MEMORANDUM

TO: Rana Adhikari, Doug Cook, Peter Fritschel, Dave Ottaway, Rick Savage,
Sam Waldman
FROM: UF IO Group
SUBJECT: Response to EOM-FI Preliminary Design Action Items
Refer to: LIGO-T060081-00-D

The preliminary design for the electro-optic modulators (EOMs) and Faraday Isolator (FI) for the initial LIGO upgrade and Advanced LIGO was presented in “Upgrading the Input Optics for High Power Operation” LIGO-E060003. This memo presents responses to action items called out by the review committee.

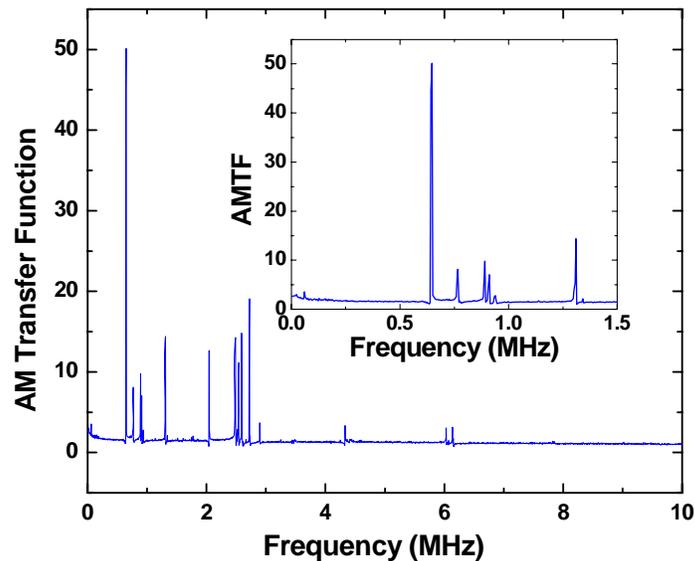
o We would like to see a test for piezo-resonances, with a frequency sweep up to at least 50 MHz. Are there piezo-resonances that need to be damped?

RESPONSE: The amplitude modulation produced by a swept sine measurement of a 4 x 4 x 20 mm³ RTP crystal is shown below from 0 to 10 MHz.

The highest lying resonance is at 6.8 MHz; typical FWHM are ~ 10 kHz. There are no features above 10 MHz up to 50 MHz.

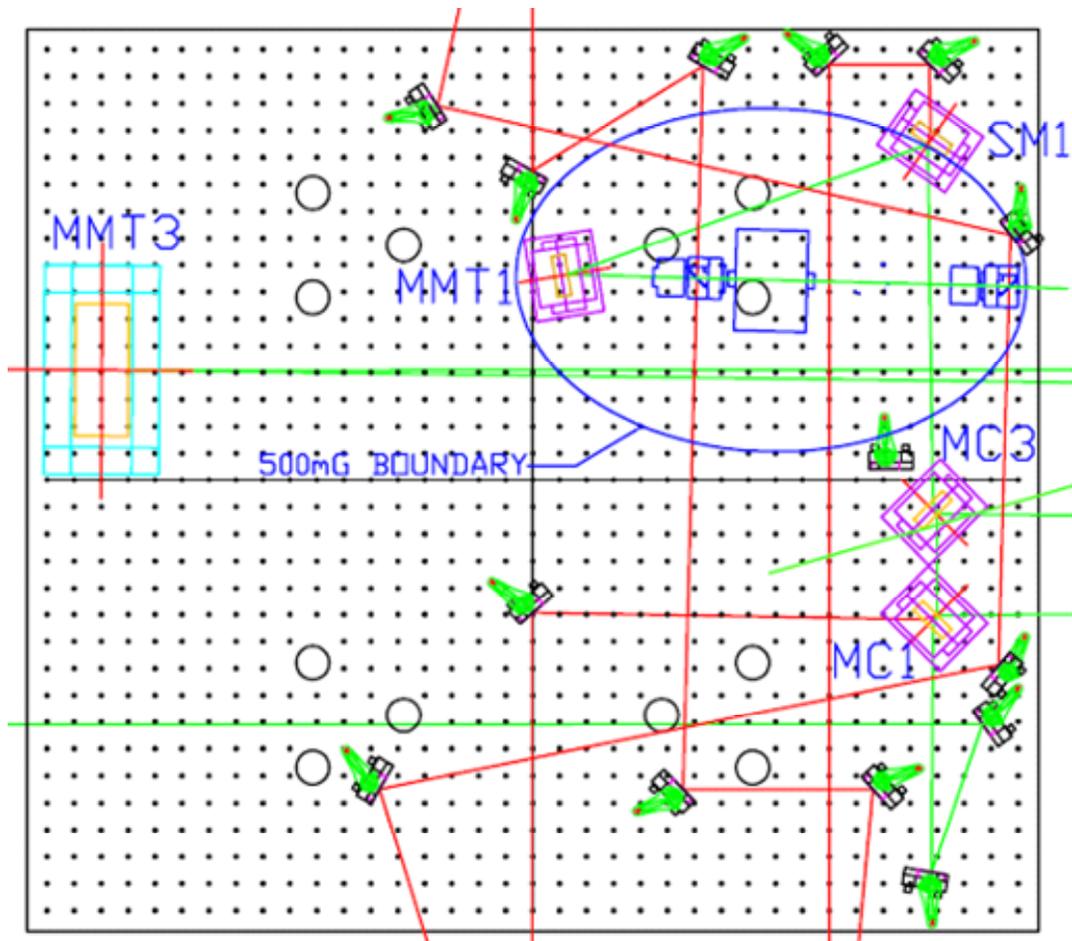
o We are unclear on the design/strategy for dealing with the different beam heights in initial and advanced LIGO; please explain.

RESPONSE: We're not sure exactly what specifically is being asked for, but here is the general idea. The layouts in the iLIGO upgrade and in AdvLIGO are quite different. Thus the strategy for the use of the AdvLIGO Faraday isolator in the iLIGO upgrade and its reuse in AdvLIGO will involve remanufacturing of the breadboard, of the structure that holds the Faraday rotator, and of the stands for the polarizers, waveplate, and steering mirrors.

Measured % losses as a function of polarization for an FI with TFPs. The MC is located to the left of the drawing; the PRM to the right.

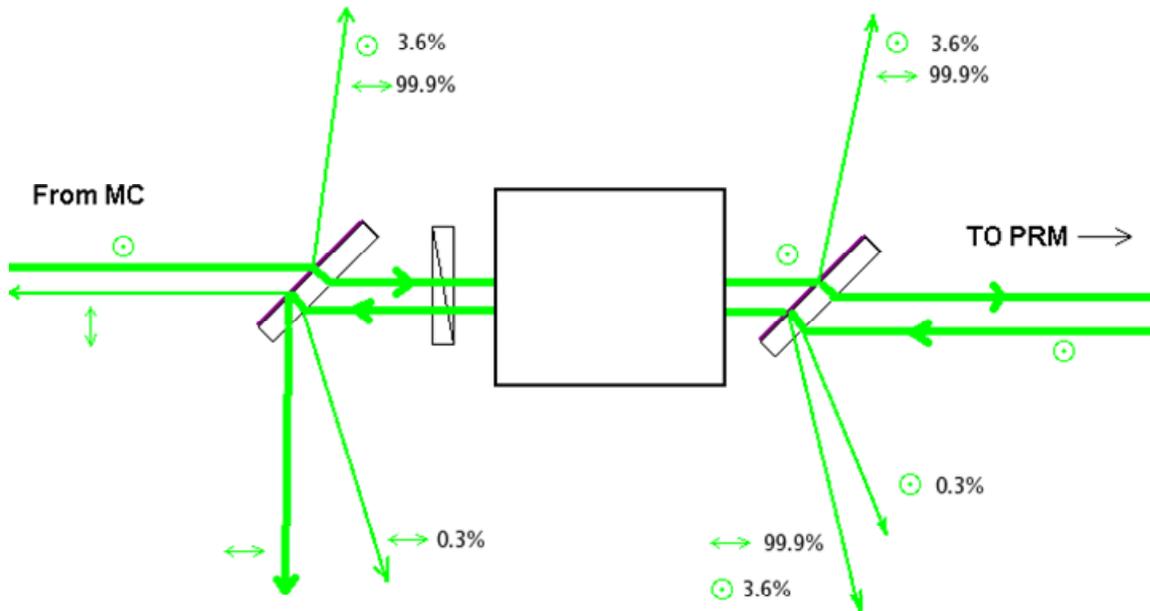
o Power budgets (section 2.2.4). Where is the power going (for both the transmitted and rejected cases)? Are all the beams being sufficiently dumped?

The drawing below shows the losses for the FI using TFPs. As is currently done in H2, we intend to capture most (or all) of the dumped beams and direct them out of the vacuum system to be available for diagnostic purposes (measure depolarization vs input power, e.g.).

Not shown are reflections from optical surfaces at near-normal incidence. Assuming 300 ppm AR coatings, beams with ~ 50 mW power levels will proliferate. Our experience from table-top investigations is that these will need to be identified and dumped during the alignment of the FI.
